Major Phased Development | DRB Recommendation - 01
SDCI # 3032055-EG (MPD # 3031301)
25 February, 2019 - Meeting Date
Planner: Brandon Cummings

RESPONSE TO EARLY DESIGN GUIDELINES COMMENTS

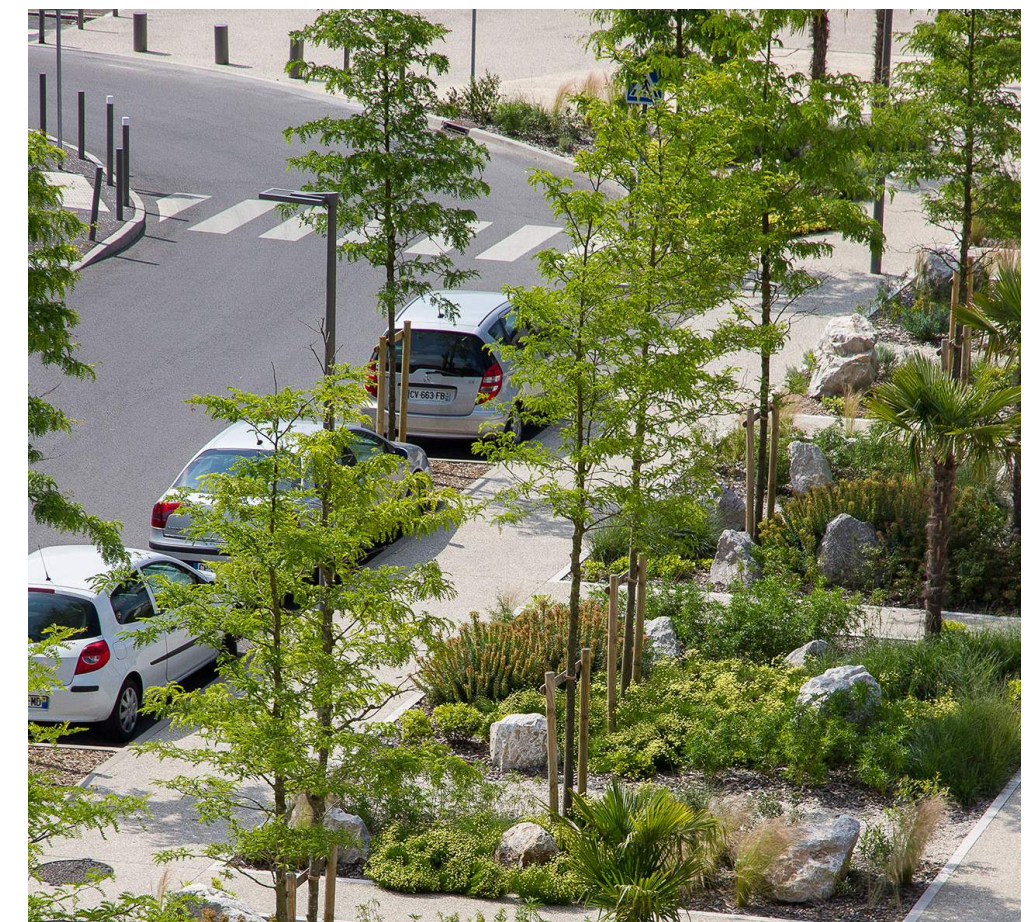
The Board also encouraged the applicant to develop a street hierarchy with multiple street typologies that promotes pedestrian activity primarily in the interior of the site and minimizes the impact of vehicular access, parking, and service uses.

Response: Development of the site plan has clarified the street hierarchy, and further refined scoring, materiality, site furnishings and lighting. The current design implements svelte roads that incorporate traffic-calming elements and minimizes the impact of vehicles, to support a vibrant pedestrian environment and bike-friendly streetscapes/amenities.

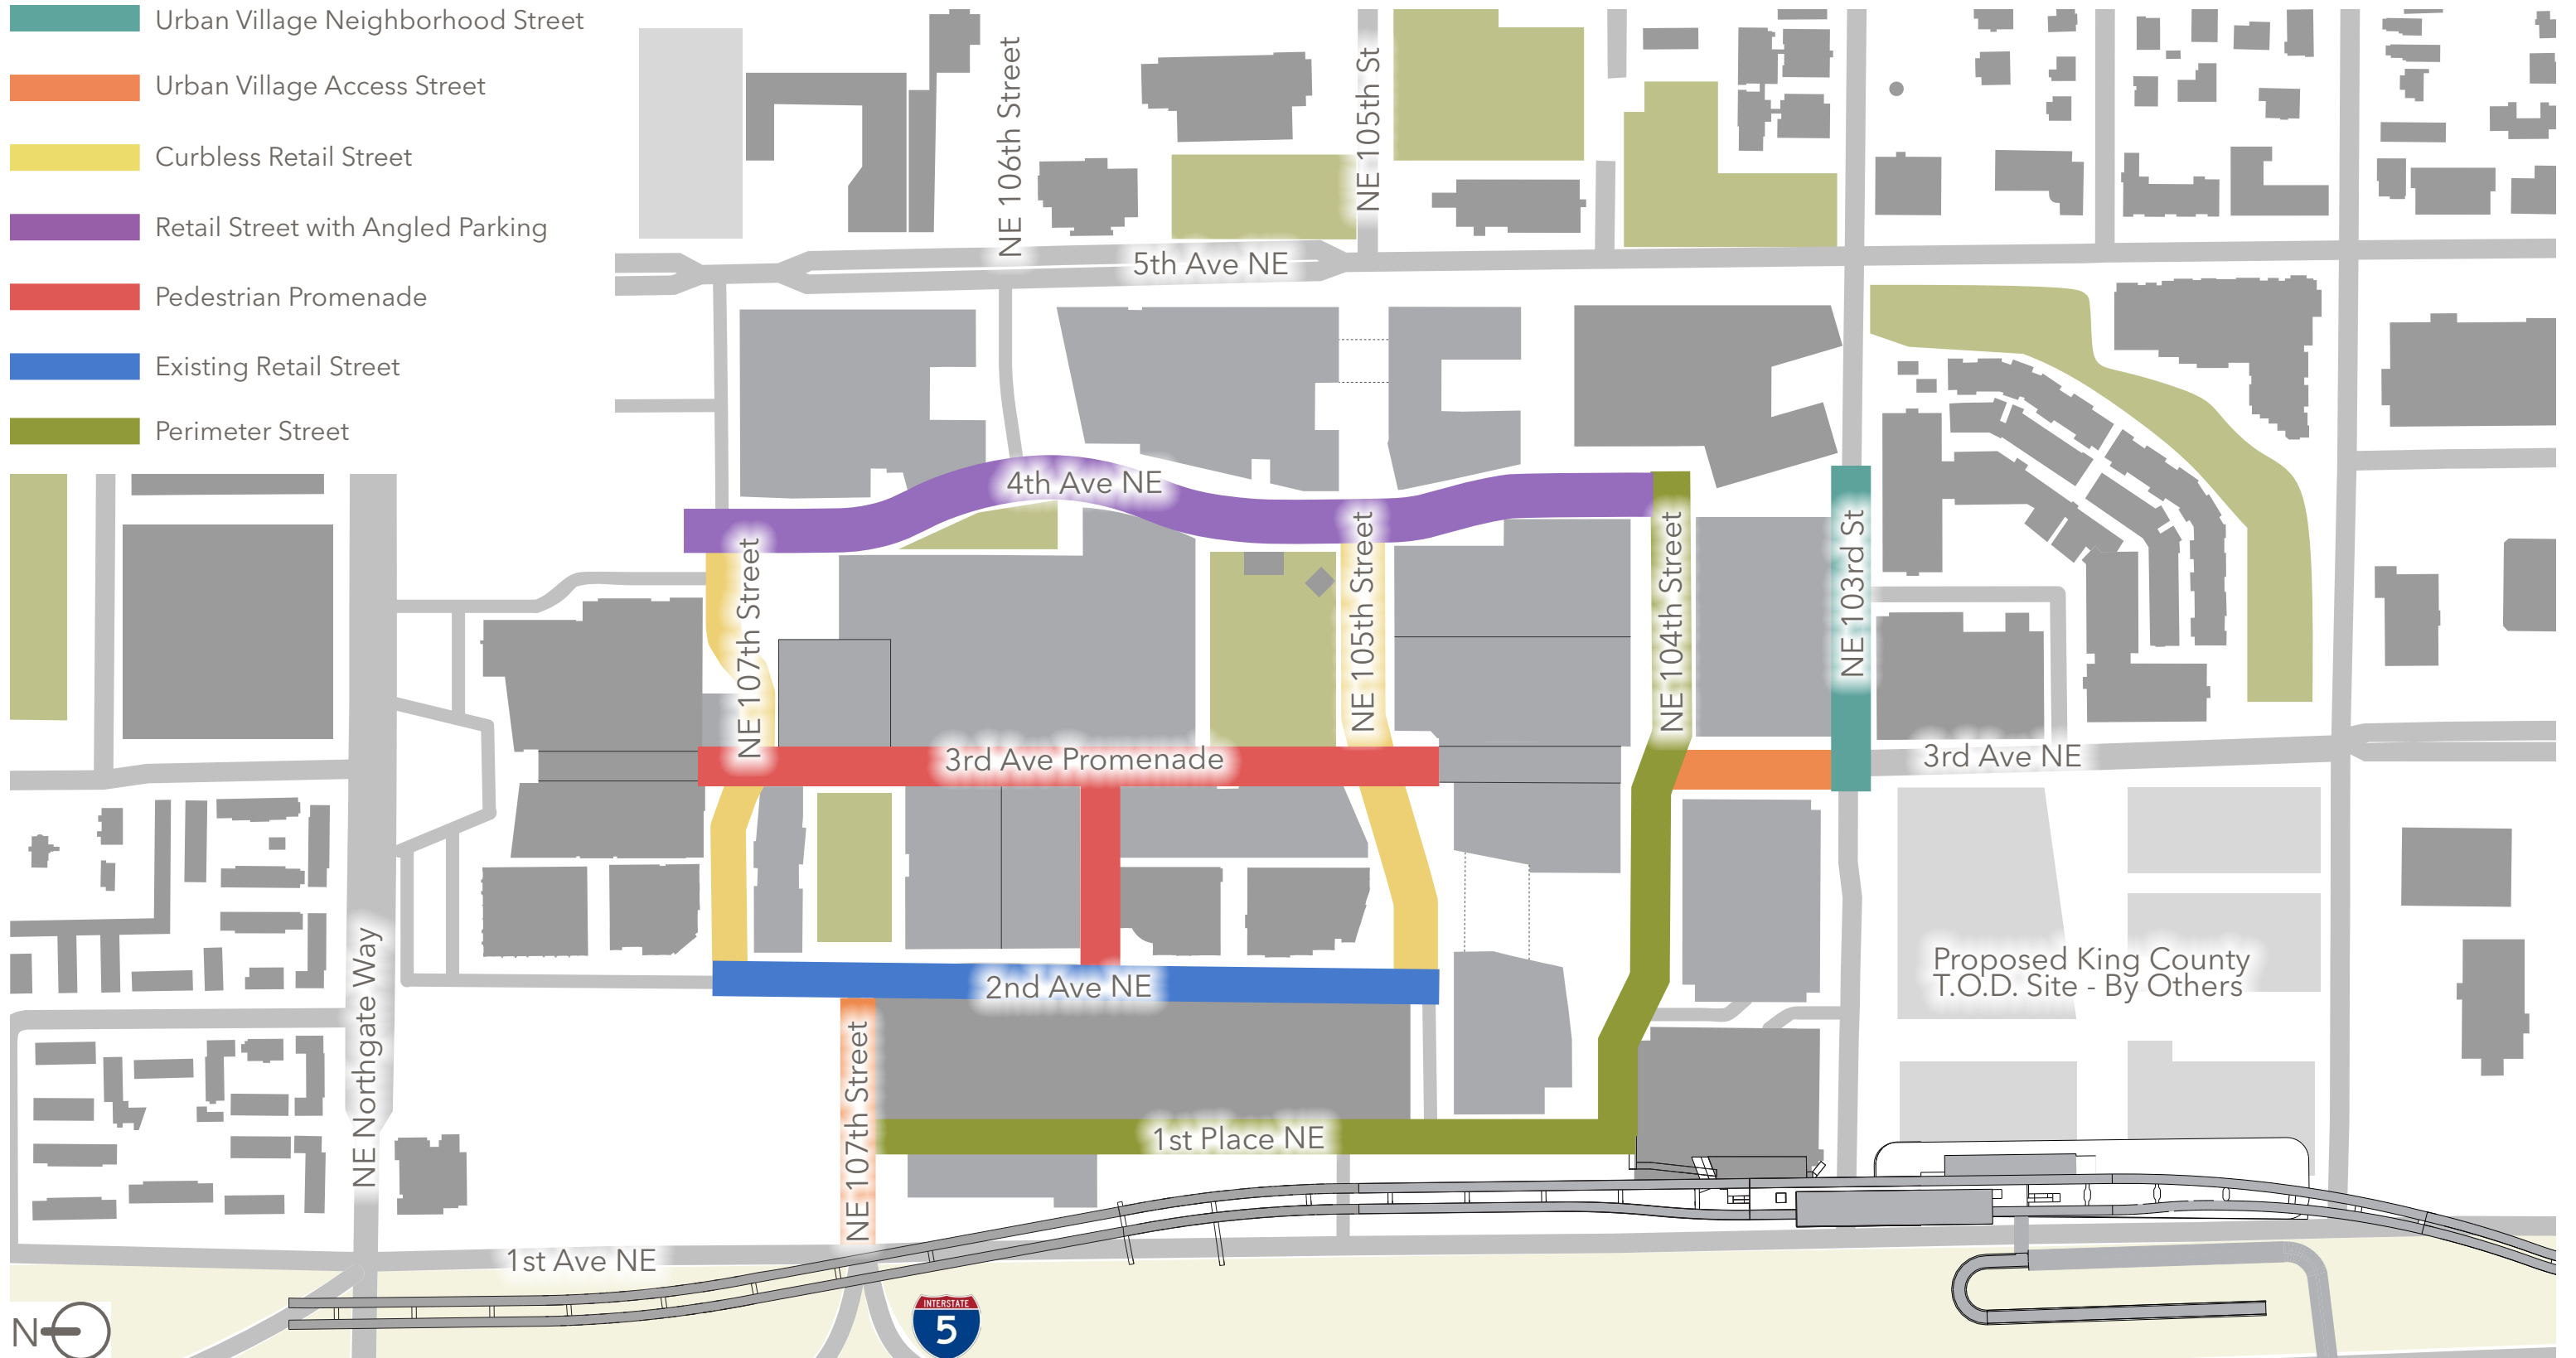
The Board was concerned with how the upper level of the Central Park fits into the overall design. Provide more information on how this area is programmed and its relationship to the 3rd Avenue Promenade and amphitheater seating.

Response: Noted. The design has evolved and includes an overlook from the promenade level onto the amphitheater, and the amphitheater mass has been broken down with planting and sculpting. Paving at the Promenade extends into the park and stitches them together. Organically-shaped planters at the promenade are repeated at the pavilions, and use similar colors as the amphitheater steps, to tie these elements together.
